**SUBJECT : Hyundai IT CORP.  
FCC ID: PJILT32DW002  
FCC Part 15 Subpart B Certification**

Transmitted herewith, on behalf of Hyundai IT CORP. is an application for a Class II Permissive Change Certification of the following 26-inch LCD TV Monitor:

**FCC ID : PJILT32DW002  
Type No. : LT32DW002**

## • Solution for EMI

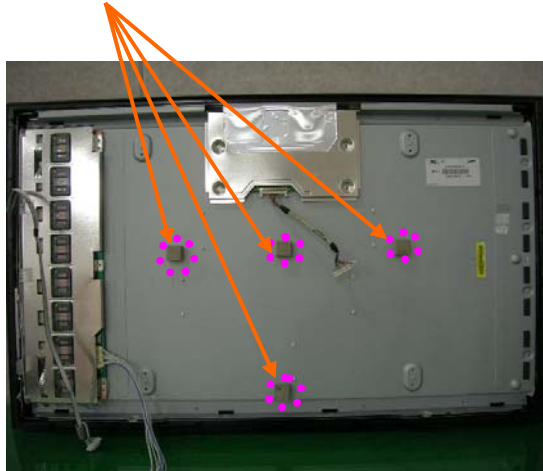
**1. Attach a gasket on the Rear frame.**

**2. Attach aluminum tape on the main board to contact the main frame**

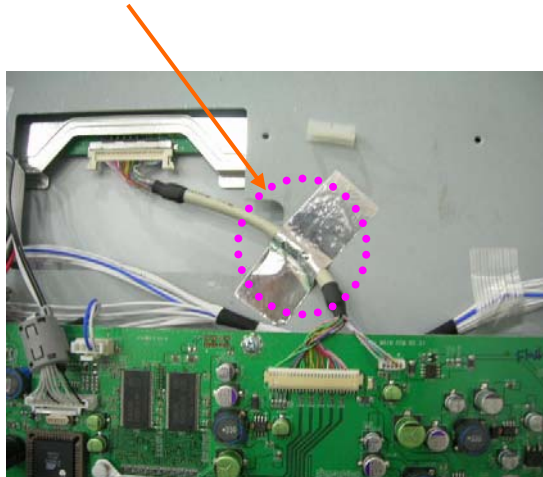
**3. Apply a ferrite core to the cable.**
